In the United States Patent and Trademark Office

Applicant                    Douglas B. Wilson  
Serial No.                10/720,821  
Confirmation No.:        5355  
Filed                        11/24/2003  
Title                        FATIGUE RELIEVING SUPPORT FOR STEERING WHEELS AND  
                              THE LIKE  
Examiner                    Vinh Luong  
Unit                        3682

APPEAL BRIEF UNDER 37 C.F.R. §41.37

# ATTACHMENT 1

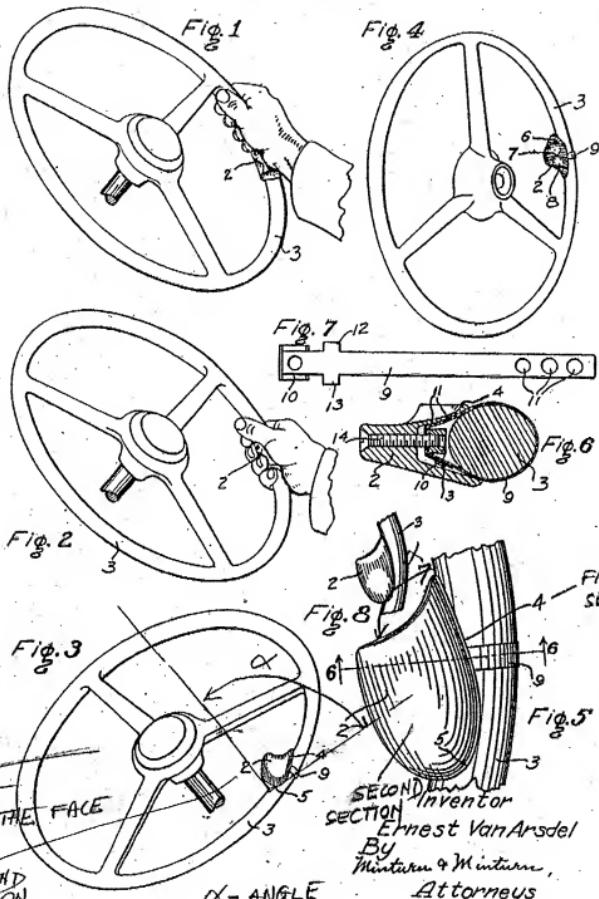
a second section 2 (i.e., upward section in Figs. 3 and 5) that connects to and extends from the first section 4 at the peripheral portion 3 of the steering wheel 3, the second section 2 extends from the first section 4 outward at an angle (see angle  $\alpha$  in Figs. 3 and 5 of the Attachment 1) to a plane (Att. 1) across a face to the steering wheel 3, with the second section 2 inherently for supporting at least a portion of a vehicular operator's body (e.g., the hand as seen

OX = ANGLE TO THE PLANE 3 OF THE STEERING WHEEL

A review of Figures 3 and 5 as annotated by the Examiner to attempt to show that the auto steering wheel handgrip of Van Arsdel is disposed outward at an angle  $\alpha$  to a plane across the face of the steering wheel shows that the Examiner's position is

misplaced. As the description above from Van Arsdel indicates, the auto steering wheel handgrip is disposed as shown in Figure 6 parallel to the plane across the face of the steering wheel not at angle to it. This is very clear because in each disposition of the auto steering wheel handgrip in the Figures, the handgrip is fixed in this parallel plane to support the thumb or part of the palm. It is also fixed so that it is not deformable so the driver can put extensive pressure on it (and it will not move) for steering the automobile (see underscored sections in the quotation above).

If the handgrip was supposed to be at an angle  $\alpha$  as the Examiner contends, the disposition of the handgrip would be shown differently in the drawings. As such, there is not support for the Examiner's contention that the handgrip is disposed other than in the plane parallel to the plane across the form of the steering wheel. Accordingly, one skilled in the art would not understand the auto steering wheel handgrip in Van Arsdel to be disposed as the Examiner contends. Moreover, there is no support in the description of the auto steering wheel handgrip in Van Arsdel that it will deform in any way out of interference with the operation of the steering wheel. Applicant submits he is justified in taking this position given the description of the connection of the hand grip as shown in Figure 6 or the integrally formed handgrip shown in Figure 8. Therefore, the auto steering wheel handgrip of Van Arsdel would not anticipate the invention as set forth in claim 20. Specifically, Van Arsdel at least does not teach or suggest the features of the second section being disposed outward at an angle from the plane across the face of the steering wheel and the handgrip of Van Arsdel does not deform as set forth in claim 20.

## **ATTACHMENT 2**

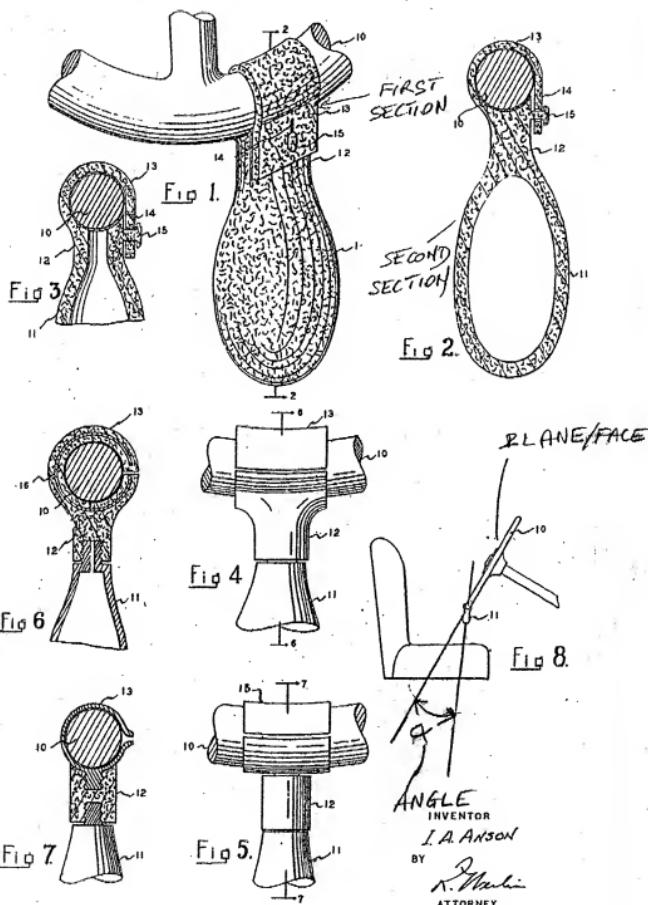
a second section 11 extends from the first section at the peripheral portion of the steering wheel 10, the second section 11 extends from the first section 13 outward at an angle (see angle  $\alpha$  in Fig. 8 of Attachment 2) to a plane (Att. 2) across a face (Att. 2) to the steering wheel 3, the second section 11 inherently for supporting at least a portion of a vehicular operator's body (e.g., the hand) when pressure from the portion of the vehicular operator's body on the second section 11 is less than the pressure for deforming the second section 11 out of interference with the vehicular operator's ability to operate the steering wheel 10, and deforming out of interference with the vehicular operator's ability to operate the steering wheel 10 when pressure from the portion of the vehicular operator's body on the second section 11 is equal to or greater than the pressure for deforming the second section 11 out of interference with the vehicular operator's ability to operate the steering wheel 10.

Given the foregoing, the steering wheel attachment of Anson at least does not teach the features of the second section being disposed outward at an angle from the plane across the face of the steering wheel (Anson extends rearward) and it does not

FIG. 4

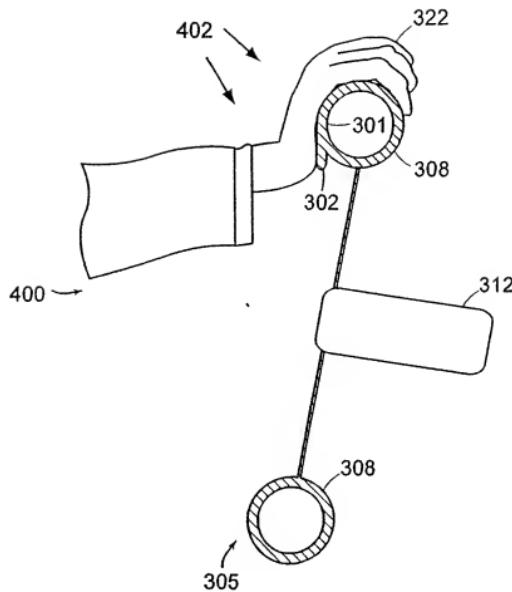
A significant aspect of the present invention is that the second section will deform out of interference with the operation of the steering wheel if it is grabbed in an emergency. This is shown graphically in Figure 4. The result is a novel apparatus that relieves or prevents fatigue when driving for extended periods of time but does not prevent the driver from grabbing the wheel in emergencies.

# ATTACHMENT 1

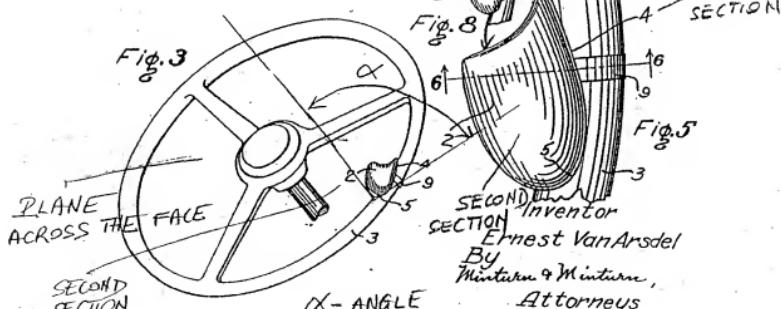
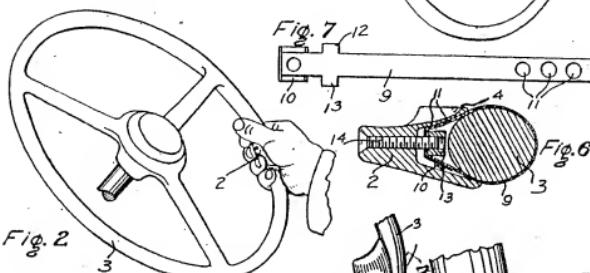
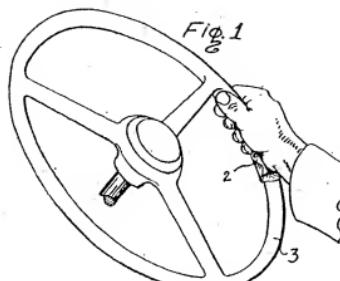
a second section 2 (i.e., a concave upward section in Figs. 3 and 5) that connects to and extends from the first section 4 at the peripheral portion 3 of the steering wheel 3, the second section 2 extends from the first section 4 outward at an angle (see angle  $\alpha$  in Figs. 3 and 5 of the Attachment 1) to a plane (Att. 1) across a face to the steering wheel 3, with the second section 2 inherently for supporting at least a portion of a vehicular operator's body (e.g., the hand as seen in Figs. 1 and 2) when pressure from the portion of the vehicular operator's body on the second section 2 is less than the pressure for deforming the second section 2 out of interference with the vehicular operator's ability to operate the steering wheel 3, and deforming out of interference with the vehicular operator's ability to operate the steering wheel when pressure from the portion of the vehicular operator's body on the second section is equal to or greater than

steering wheel rim 3 in a manner to slope downwardly and inwardly of the rim. The outer edge 4 of the side, and 5 of the rear end of the *concave*, located above the rim, *extends up into a marginal flange* to be contacted by the inside of the ball of the thumb or by the bottom of the hand, depending upon which part of the hand is seated to rest." See also Arsdel's claims 1 and 2. Arsdel's concave upward section 2 extends from the first section 4 outward at an angle  $\alpha$  to the plane across the face of the steering wheel as seen in Figs. 3 and 8 of Attachment 1. Therefore, Arsdel's concave upward section 2 in Fig. 3 of Arsdel "reads on" Applicant's claimed second section.

$\alpha$  = ANGLE  
TO THE  
PLANE 3  
OF THE STEERING WHEEL

## **ATTACHMENT 2**

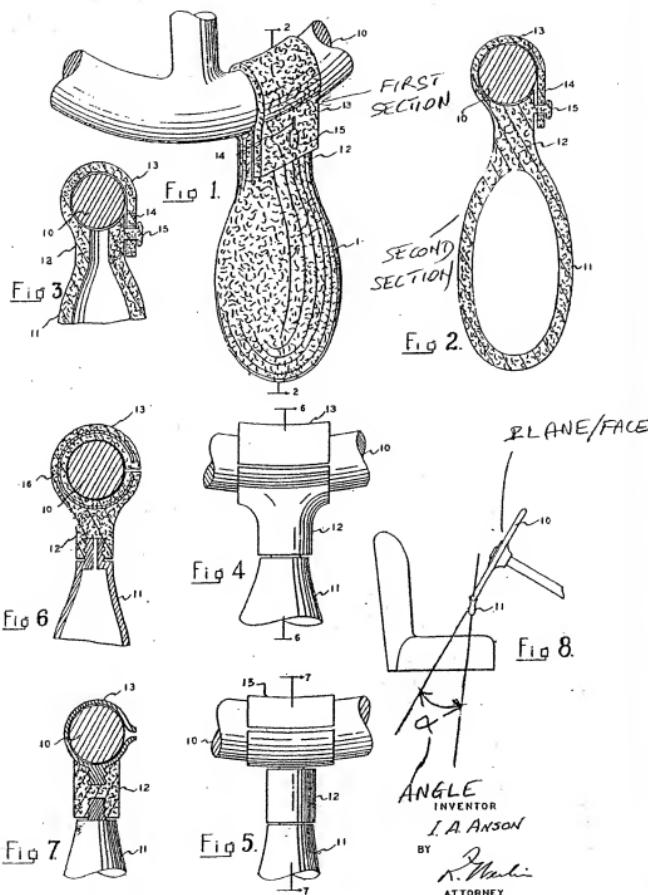
a first section 13 that connects to a peripheral portion of the steering wheel 10; a second section 11 extends from the first section at the peripheral portion of the steering wheel 10, the second section 11 extends from the first section 13 outward at an angle (see angle  $\alpha$  in Fig. 8 of Attachment 2) to a plane (Att. 2) across a face (Att. 2) to the steering wheel 3, the second section 11 inherently for supporting at least a portion of a vehicular operator's body (e.g., the hand) when pressure from the portion of the vehicular operator's body on the second section 11 is less than the pressure for deforming the second section 11 out of interference with the vehicular operator's ability to operate the steering wheel 10, and deforming out of interference with the vehicular operator's ability to operate the steering wheel 10 when pressure from the portion of the vehicular operator's body on the second section 11 is equal to or greater than the pressure for deforming the second section 11 out of interference with the vehicular operator's ability to operate the steering wheel 10.

outward such that the second section 11 is at an angle from the plane across the face of the steering wheel and out of interference with the operation of the steering wheel as claimed. On the other hand, it is well settled that a claim containing a "recitation with respect to the manner in which a claimed apparatus is intended to be employed does not differentiate the claimed apparatus from a prior art apparatus" if the prior art apparatus teaches all the structural limitations of the claim. *Ex parte Masham*, 2 USPQ2d 1647 (Bd. Pat. App. Inter. 1987) and MPEP 2114. In the case at hand, Anson teaches all structural limitations in the claims, therefore, Applicant's contention regarding the manner in which the claimed device is intended to be employed is unpersuasive.

## **ATTACHMENT 1**

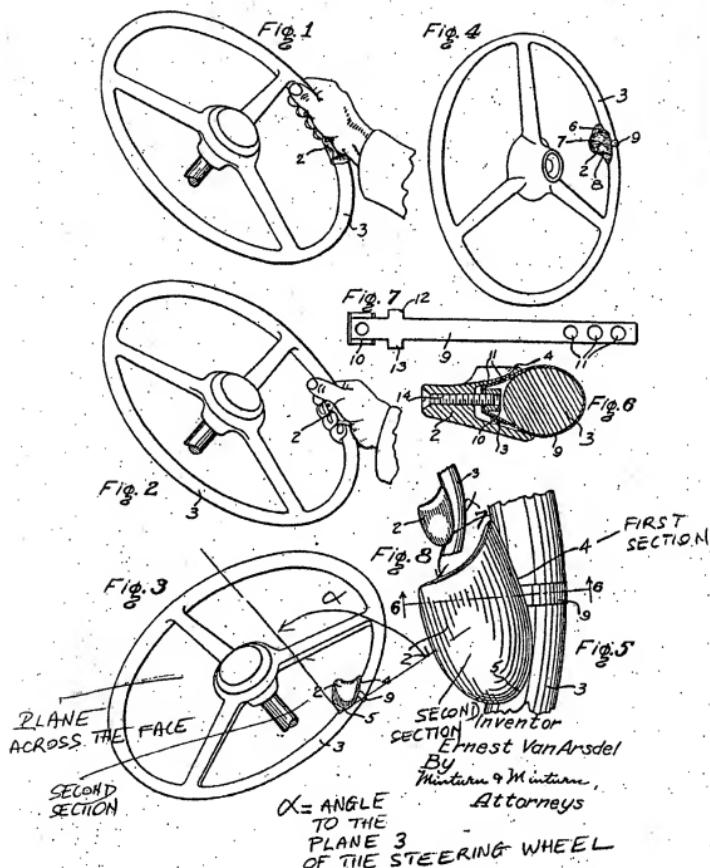
a second section 2 (*i.e.*, a concave upward section in Figs. 3 and 5) that connects to and extends from the first section 4 at the peripheral portion 3 of the steering wheel 3, the second section 2 extends from the first section 4 outward at an angle (see angle  $\alpha$  in Figs. 3 and 5 of the Attachment 1) to a plane (Att. 1) across a face to the steering wheel 3, with the second section 2 inherently for supporting at least a portion of a vehicular operator's body (e.g., the hand as seen in Figs. 1 and 2) when pressure from the portion of the vehicular operator's body on the second section 2 is less than the pressure for deforming the second section 2 out of interference with the vehicular operator's ability to operate the steering wheel 3, and deforming out of

## **ATTACHMENT 2**

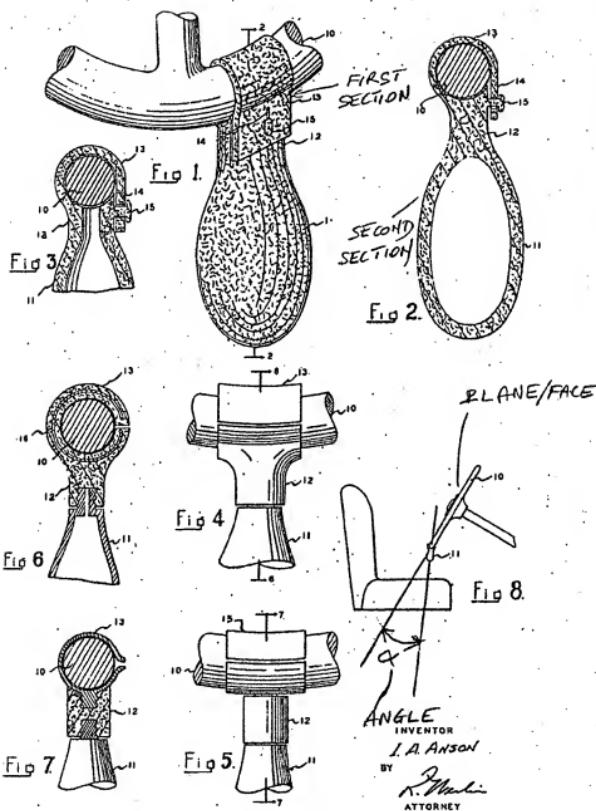
a second section 11 extends from the first section at the peripheral portion of the steering wheel 10, the second section 11 extends from the first section 13 outward at an angle (see angle  $\alpha$  in Fig. 8 of Attachment 2) to a plane (Att. 2) across a face (Att. 2) to the steering wheel 3, the second section 11 inherently for supporting at least a portion of a vehicular operator's body (e.g., the hand) when pressure from the portion of the vehicular operator's body on the second section 11 is less than the pressure for deforming the second section 11 out of interference with the vehicular operator's ability to operate the steering wheel 10, and deforming out of interference with the vehicular operator's ability to operate the steering wheel 10 when pressure from the portion of the vehicular operator's body on the second section 11 is equal to or greater than the pressure for deforming the second section 11 out of interference with the vehicular operator's ability to operate the steering wheel 10.

Further, since Anson's *attachment may be rotated about the wheel rim* from its normal pendent position to a position within the periphery of the wheel when it becomes desirable to dispense with its use in operating the wheel, Anson's attachment is capable to be rotated outward such that the second section 11 is at an angle from the plane across the face of the steering wheel and out of interference with the operation of the steering wheel as claimed. On the other hand, it is well settled that a claim containing a "recitation with respect to the manner in which a claimed apparatus is intended to be employed does not differentiate the claimed apparatus from a prior art apparatus" if the prior art apparatus teaches all the structural limitations of the claim. *Ex parte Masham*, 2 USPQ2d 1647 (BPAI 1987) and MPEP 2114.

## **ATTACHMENT 3**

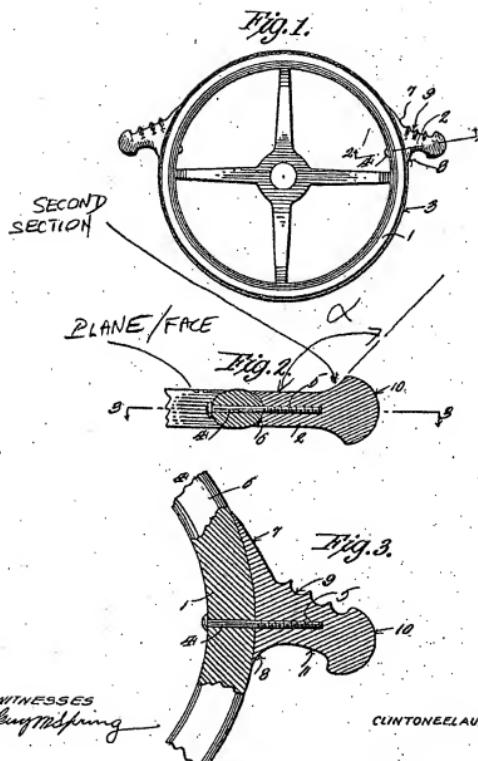
a first section 7, 8 that connects to a peripheral portion of the steering wheel 1;  
a second section 10 that connects to, and extends from, the first section 7, 8 at the peripheral portion of the steering wheel 1, the second section 10 extends from the first section 7, 8 outward at an angle (see angle  $\alpha$  in Fig. 2 of the Attachment 3) to a plane (Att. 3) across a face (Att. 3) to the steering wheel 1, the second section 10 inherently for supporting at least a portion of a vehicular operator's body (e.g., the hand) when pressure from the portion of the vehicular operator's body on the second section 10 is less than the pressure for deforming the second

Applicant further asserted that the knob of Laubach does not deform out of interference with the operation of the steering wheel as set forth in claim 20. The Examiner respectfully submits that the driver can unscrew Laubach's screws 5, and then screw or fasten the screws 5 at other position on the rim 6 of the steering wheel such that the new position is out of interference with the operation of the steering wheel as the driver so desires. The operation to adjust or change the position of Laubach's handgrips is similar to the operation to adjust the handgrip of Arsdel since both Laubach and Arsdel use the screws as the fastening means. Since the position of Laubach's knobs is capable of being changed to be out of interference with the operation of the steering wheel, *i.e.*, Laubach's knobs can inherently performed the functions recited in

The description of the knobs and a review of the Figures makes plain that the knobs are not deformable and they are not disposed at an angle with respect to the plane across the face of the steering wheel. The knobs are rigidly connected to the steering wheel by screws 5. Any movement of them requires removing the screws, drilling the wheel at a new location, and reattaching the knobs at the new location. At this new location, the knobs will be in a plane parallel to the plane across the face of the steering wheel.
